REASON FOR UPDATE:

- For applications with a jounce stop
- Installation and fitment requirements

Applications	
Year	2017-2023
Make	Ford
Models	F250/F350/F450 (4WD)

Diagram 2

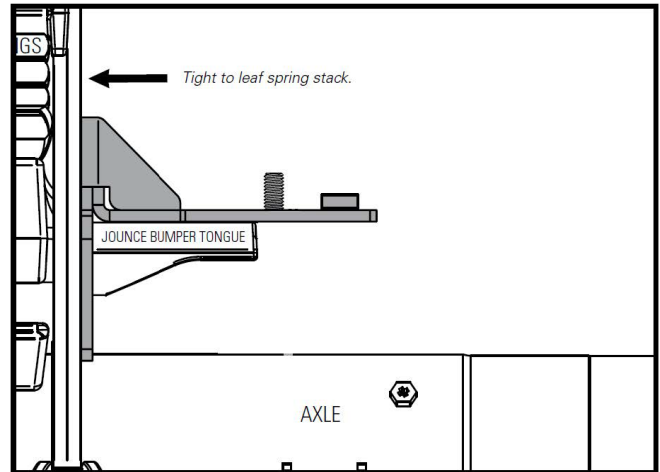
- When installing the lower bracket (5938 or 5948) be sure that the bracket is sitting down on the jounce stop. See “Diagram 2”:

Diagram 1

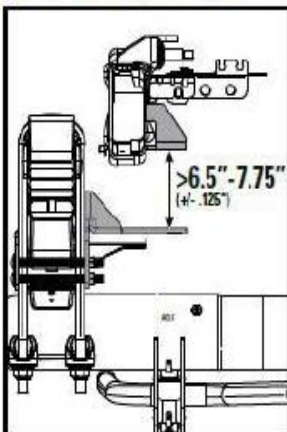
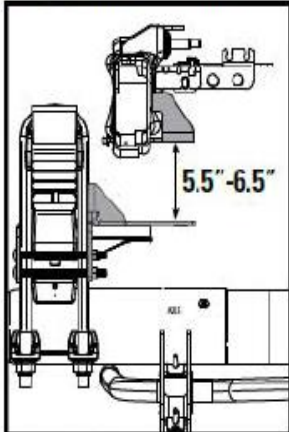
- When securing the air springs to the lower brackets, use part number 3514 (1.0” Flat Head Cap Screws) when the 1.5” spacer (5336) is not being used.
- When using the 1.5” spacer (5336), use part number 3430 (2.0” Flat Head Cap Screw) to secure the air spring to the air springs to the lower brackets.
- Do not use the 1” Flange Bolt (3106) or the 2” Flange Bolt (3150) to secure the air spring to the lower bracket. Using the Flange Bolts will not allow the lower bracket (5938) to sit down on the jounce stop. See “Diagram 1”:
